RIVER DISTRICT DESIGN COMMISSION REGULAR MEETING AGENDA

DATE: September 12, 2024
TO: River District Design Commission
FROM: Renee Burton, Division Director of Planning
RE: Certificate of Appropriateness application PZ24-00442 filed by Adam Vaught to replace windows and doors at 400 Bridge Street (Parcel 21490).

DATE: September 12, 2024
TO: River District Design Commission
FROM: Renee Burton, Division Director of Planning
RE: Certificate of Appropriateness PZ24-00483 filed by Seven Diamonds LLC to add new windows at 521 Bridge Street (Parcel 21485).

1 EXISTING WINDOW ELEVATIONS
1/2" = 1'-0"

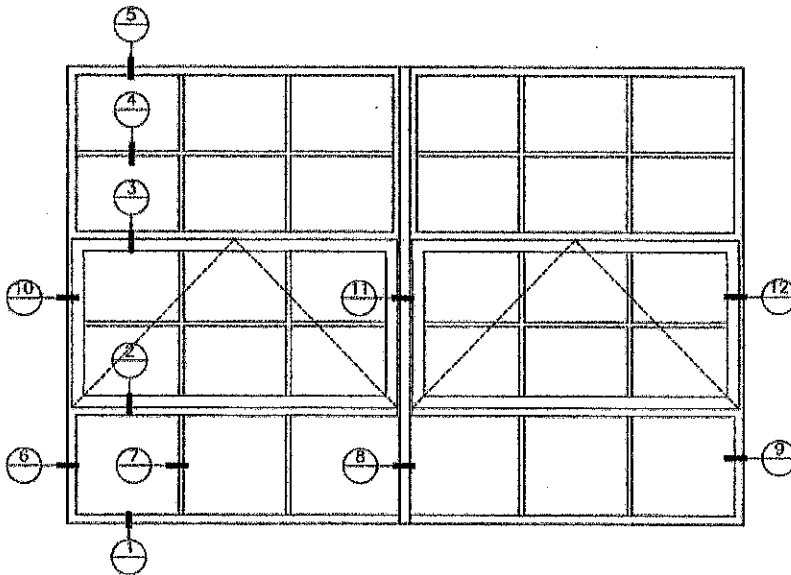
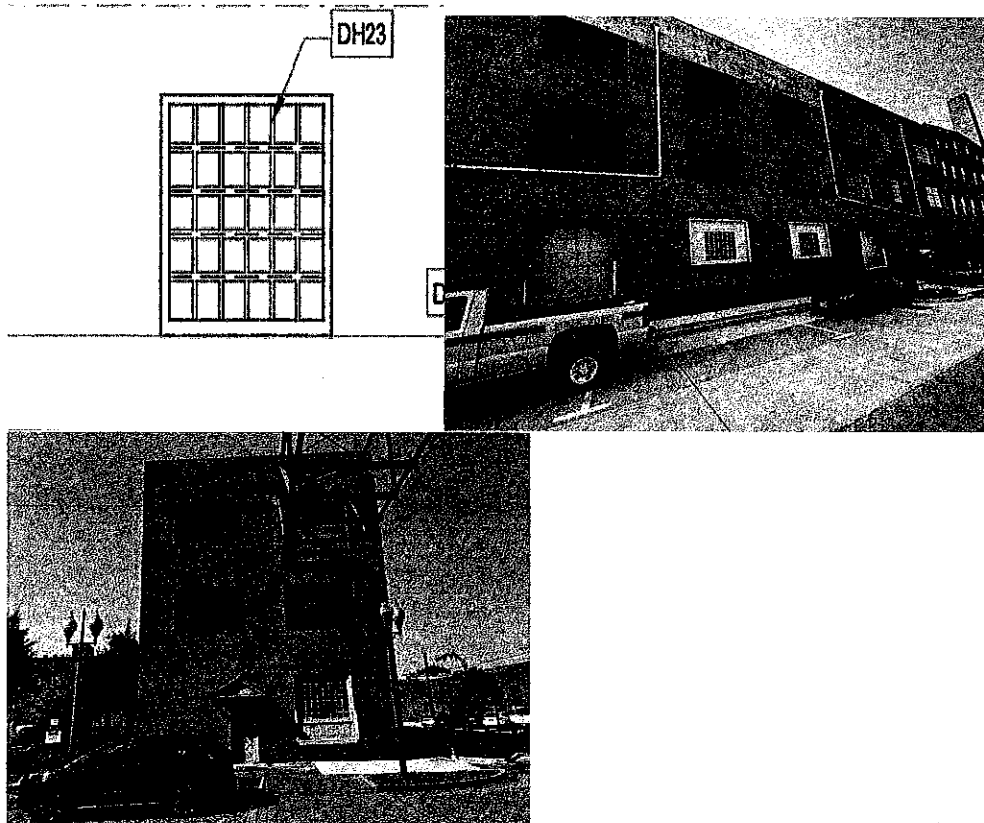
The non-historic first floor windows will be replaced to match the second- and third-floor windows. The garage doors include two facing Wilson Street and two on the front elevation, one on the first floor and one on the third floor. These will be replaced with storefront windows. The door on the Bridge Street elevation will be replaced with a new wood 1/2 light over three-panel door. Finally, the infill with door located in the breezeway will be replaced with storefront windows and a door. Due to the elevation of this door, a concrete stair and ramp with steel rails are proposed.

- 1) Replacement of non historic 1st floor windows to match existing historic windows on the 2nd and 3rd floor.

- 2) Remove existing garage doors and install historic tax credit approved replacement using storefront material. This will include 2 on the 1st floor level facing Wilson Street as well as 1 on the 1st floor & 1 on the 3rd floor facing Bridge Street.

The Planning Staff recommends approval of PZ24-00442 to replace windows and doors at 400 Bridge Street (Parcel 21490).

NEW STOREFRONT DOOR

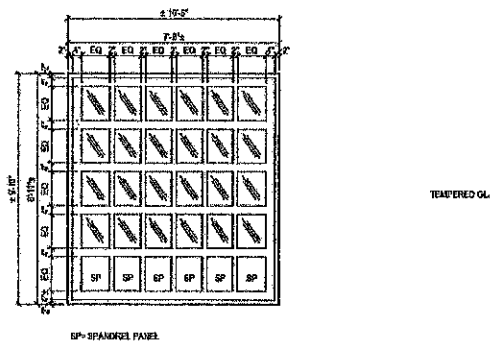
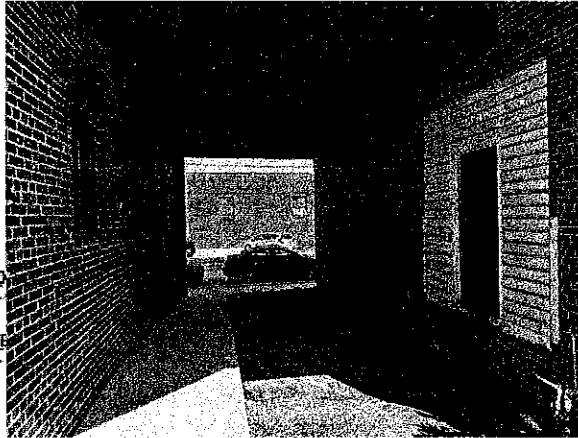
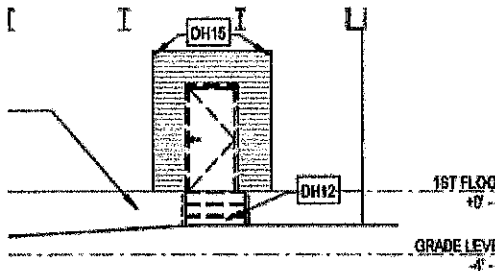
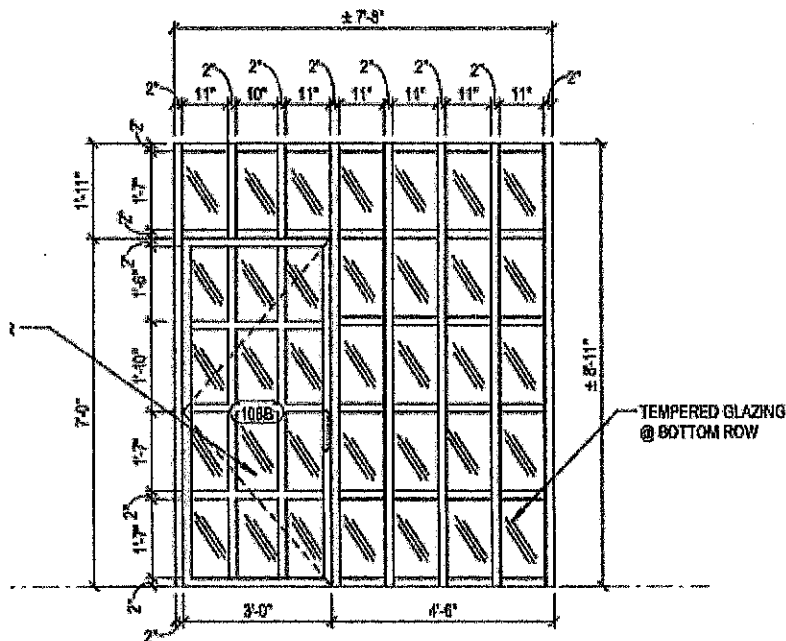
- 3) Remove non historic infill where a garage door used to be in the breezeway off of Wilson Street. This will be one of the primary accesses to the building. Therefore, this replacement will have the same configuration as the other replacements except it will have a door incorporated into it.

RENOVATION ELEVATION BREEZEWAY ELEVATION

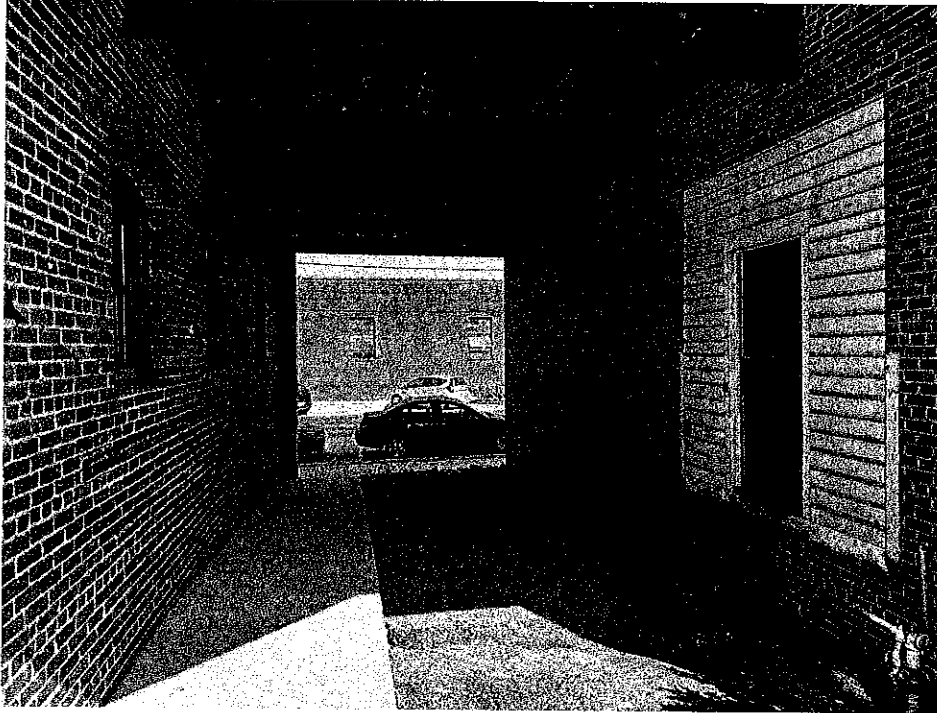
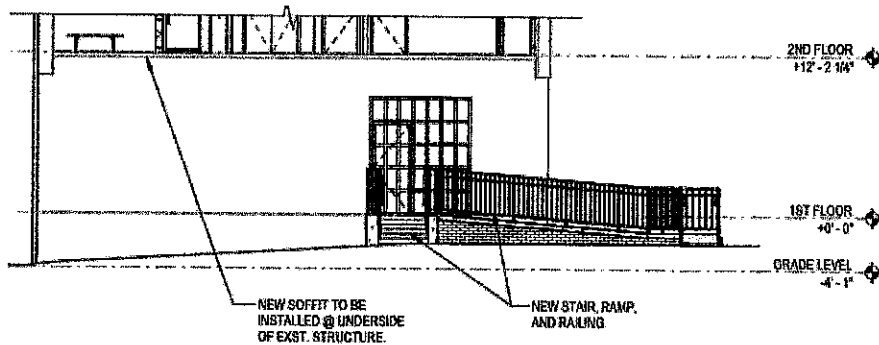
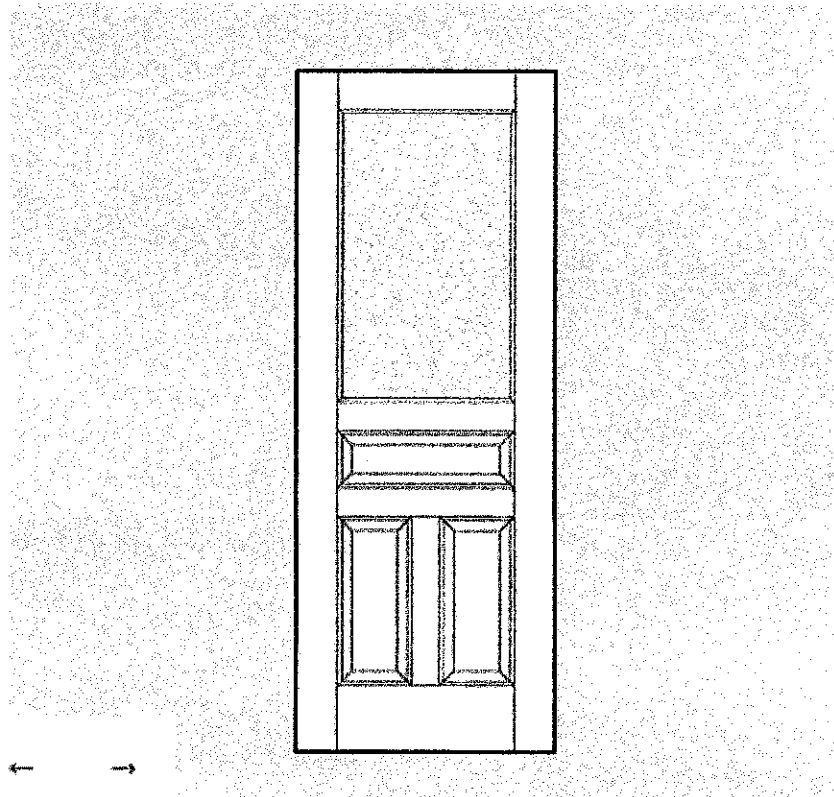
- 4) In order to achieve code compliant access to the door referenced above, we will need to add a stair and ramp. We are proposing to do this using concrete for the structure of the ramp & rails with simple steel rails.

RENOVATION EXTERIOR ELEVATION

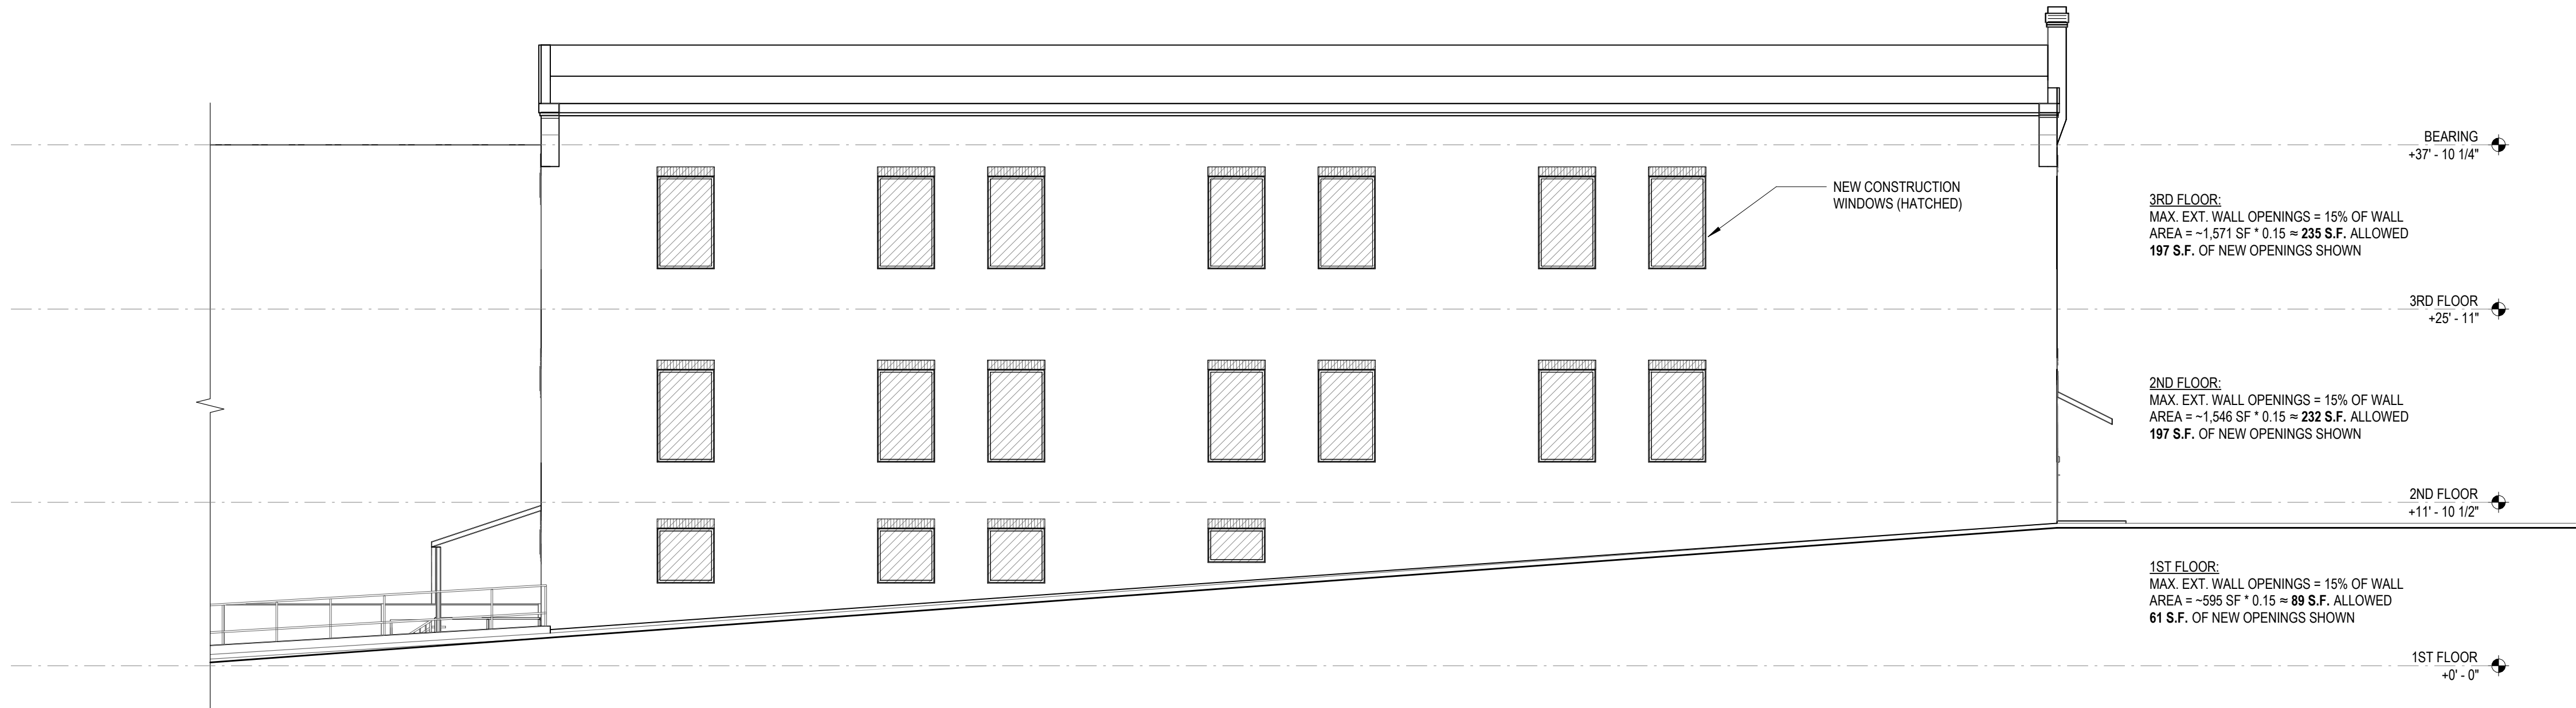
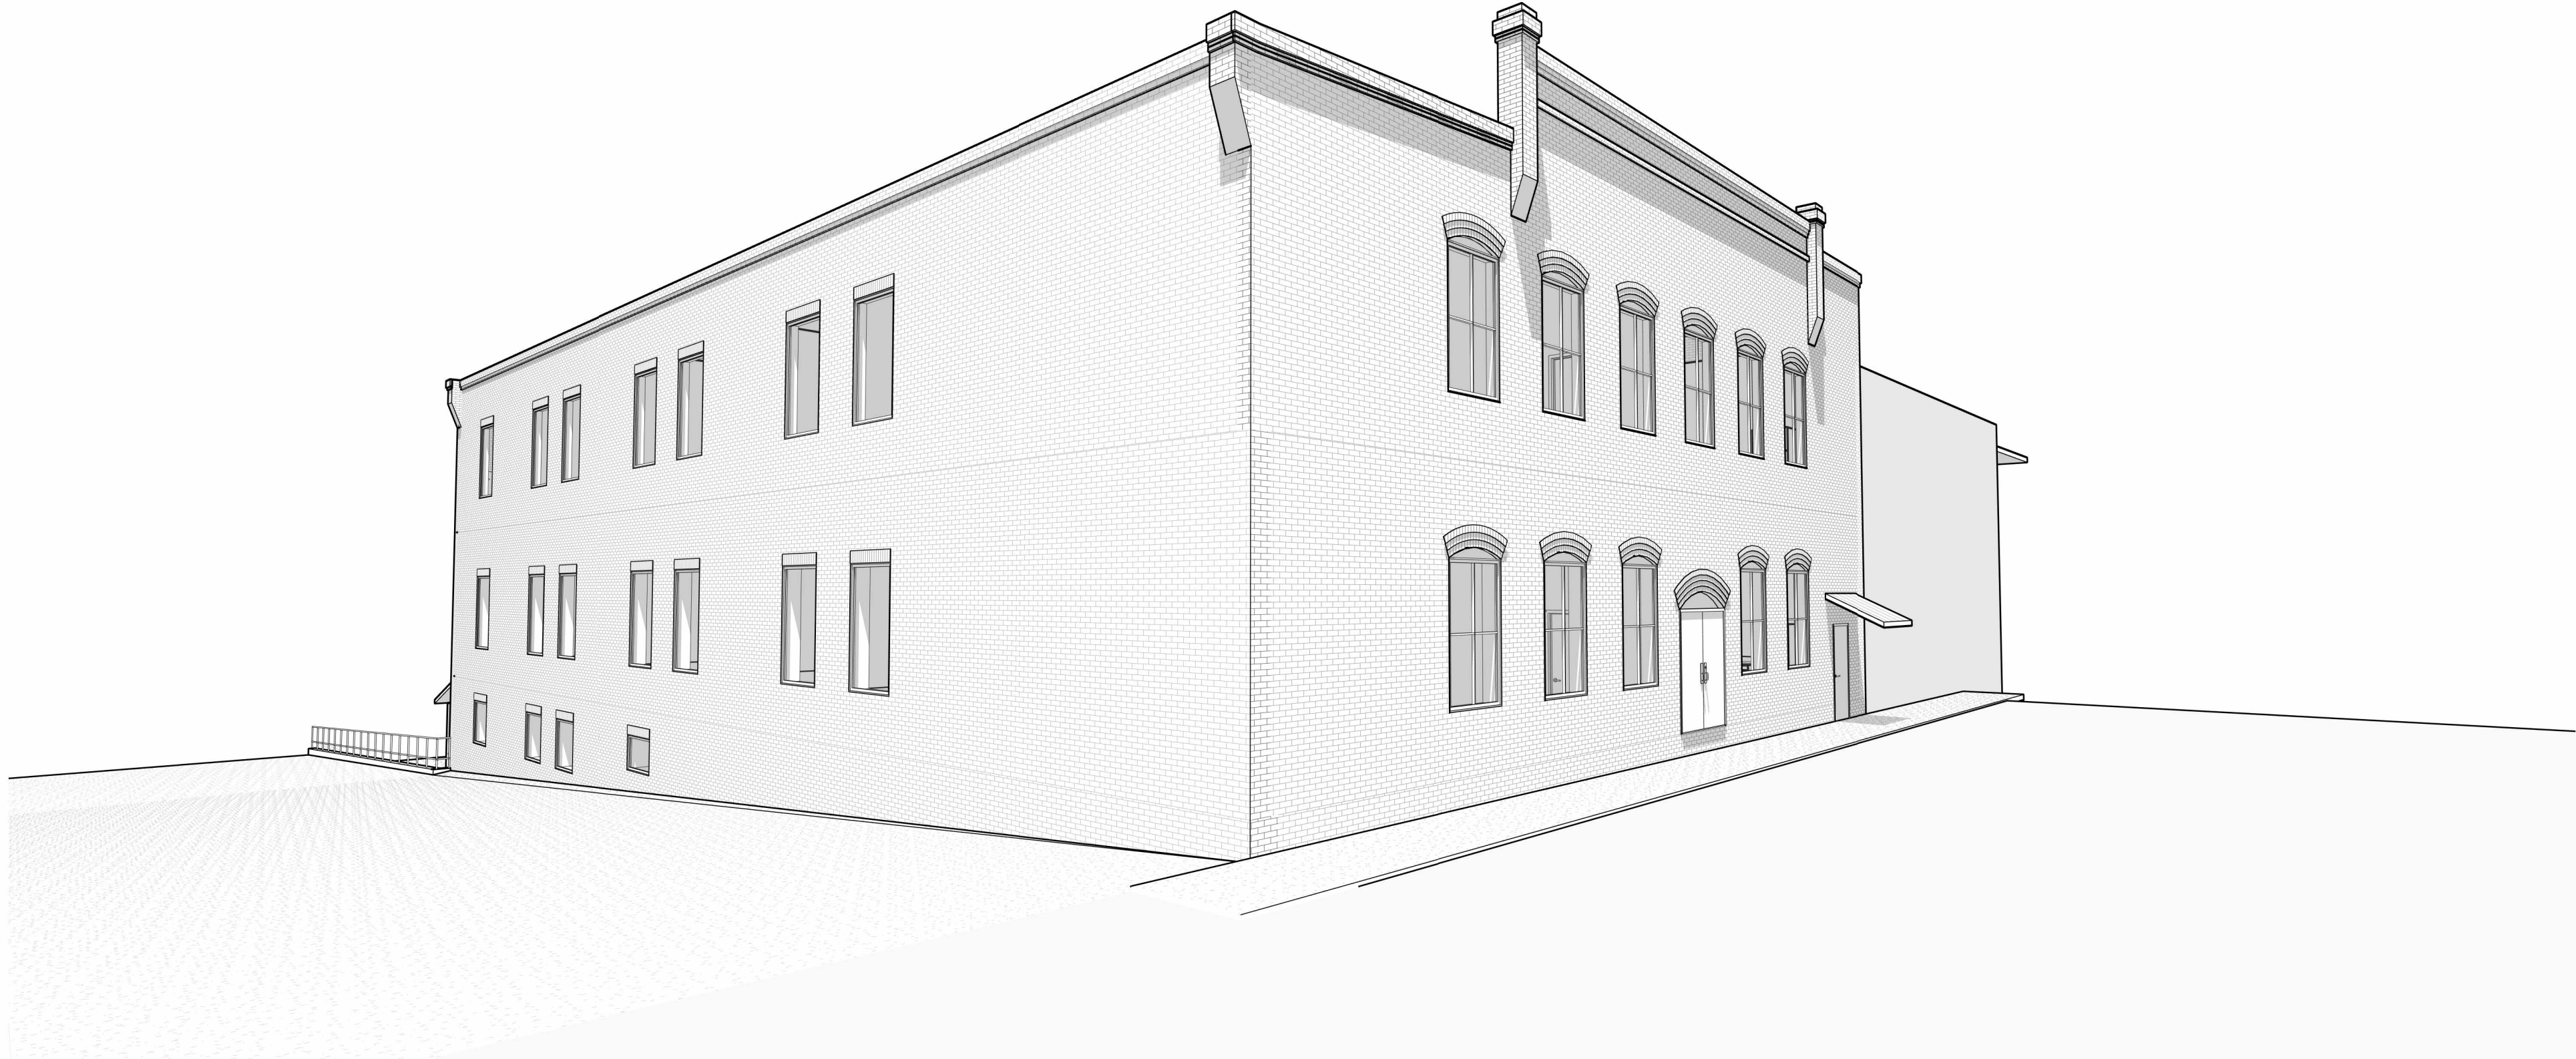
The west elevation of 521 Bridge Street currently has no windows. The applicant will install windows similar in size and spacing to the existing windows but with different muntins and without the arched brick above to differentiate them from the existing historic windows. The applicant has stated that this difference is in line with the current VDHR guidelines. The applicant anticipates the new windows to be aluminum clad. However, the new window material and muntin pattern will be finalized at a later time.

The proposed design complements the historic window configuration while differentiating enough to not create a false history. Windows have not been reviewed by VDHR. Reviews may alter window configuration. Any alterations would require additional review by the River District Design Commission.

The Planning Staff recommends approval of PZ24-00483 to add new windows at 521 Bridge Street (Parcel 21485).
